100GBASE-SR4: Effects of Instrument Noise Comments i-25, i-26, i-27 & i-28

John Petrilla: Avago Technologies
July 2014

Ref Rx Sensitivity & Observed Tx 5E-5 Contours

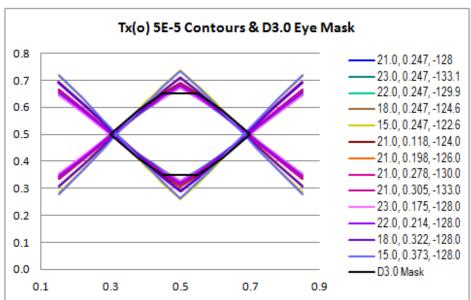
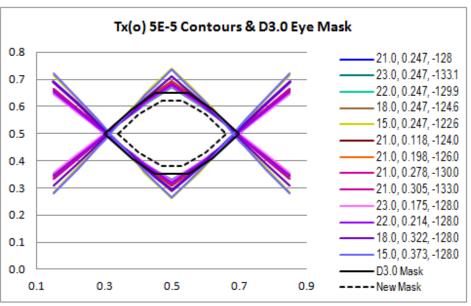
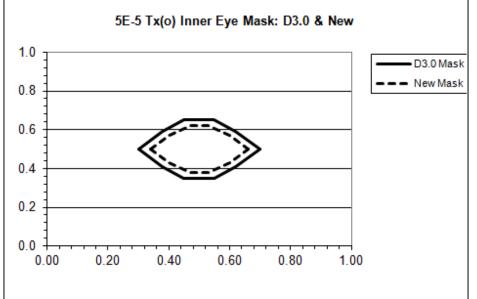
Comments i-25 & i-27

- •The chart on the left shows the expected observed Tx TP2 5E-5 contours for a set of worst case transmitters at the time of the March 2014 meeting with the inner eye mask that is defined in Draft 3.0 These contours were based on an expected oscilloscope dark RMS input noise of 4.5 μ W for a 19.3 GHz optical plug-in. Since then the expectation for dark RMS input noise has changed to 17 μ W. This results in shift from an expected RJ of ~0.24 UI in the mask test to an expected RJ of ~0.36 UI.

- •The chart on the right shows expected observed Tx TP2 5E-5 contours for a set of worst case transmitters based on a scope with an expected dark RMS input noise of 17 μ W for a 19.3 GHz optical plug-in. None of the worst case contours will pass the currently defined eye mask.

- •It may be possible to keep the same mask coordinates by reducing the hit ratio from 5E-5 to 1.5E-3 (reduces RJ from 0.36 UI at 5E-5 to 0.24 UI at 1.5E-3.

- •A new 5E-5 hit ratio mask is proposed on the following page.

Ref Rx Sensitivity & Tx Eye Mask Coordinates

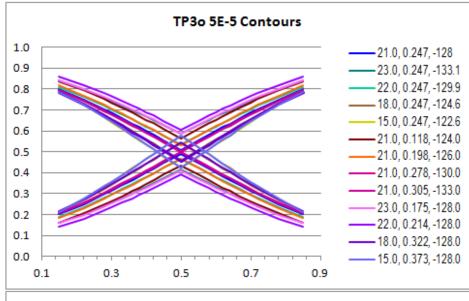
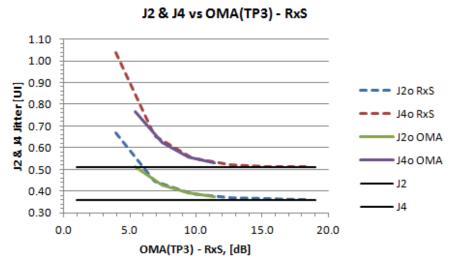
Comments i-25 & i-27

- •The chart on the upper left repeats a chart from the prior page.
- •The charts on the upper right and lower left show a newly proposed Tx eye mask that accounts for the currently expected oscilloscope input noise.
- •Eye mask coordinates X1, X2, X3, Y1, Y2, Y3 Draft 3.0: 0.30, 0.38, 0.45, 0.35, 0.41, 0.5 New: 0.34, 0.40, 0.47, 0.38, 0.43, 0.5

Update to comment i-25

•Change X1 (from 0.3 to 0.34), X2 (from 0.38 to 0.4), X3 (from 0.45 to 0.47), Y1 from 0.35 to 0.38), Y2 (from 0.41 to 0.43), Y3 (0.5 no change).

Ref Rx Sensitivity & BW & Stressed Rx Sensitivity Conditions

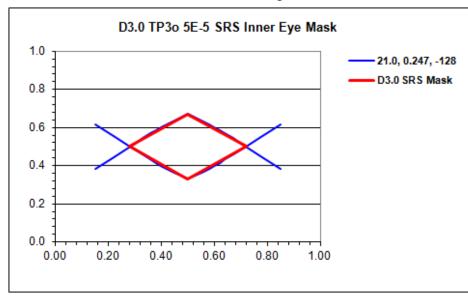
Comments i-26 & i-28

- •The chart shows expected observed 5E-5 contours for the worst case Tx labeled (21.0, 0.247, -128) based on a scope with an expected dark RMS input noise of 17 μ W for a 19.3 GHz optical plug-in and a signal ~ 10 dB above the scope sensitivity. The resultant eye appears suitable for calibration of stressed receiver sensitivity conditions.
- •The SRS eye mask defined in D3.0 is included. No adjustment appears needed for the stressed receiver eye mask coordinates or VECP.

Update to comment i-26

•Change J2 from 0.41 UI to 0.39 UI.

No changes are needed for J4 (0.55 UI), VECP (4.2 dB) and eye mask coordinates, X1 (0.28 UI), X2 (0.5 UI), X3 (0.5 UI), Y1 (0.33 UI), Y2 (0.33 UI), Y3 (0.4 UI).

Update to comment i-28

- •Change the first sentence in the first paragraph of 95.8.8.4 from "The stressed receiver conformance test signal can be verified using an optical reference receiver with an ideal fourth-order Bessel-Thomson response with a reference frequency fr of 19.34 GHz." to "The stressed receiver conformance test signal can be verified using an optical reference receiver with an RMS input noise of 17 microwatts and ideal fourth-order Bessel-Thomson response with a reference frequency, fr, of 19.34 GHz."
- •Insert after the first sentence of the last paragraph of 95.8.8.4 the following, "The signal amplitude at the reference receiver input shown in Figure 95-3 while calibrating the stressed receiver conditions shown in Table 95-7 should be 10dB above the sensitivity of the reference receiver."
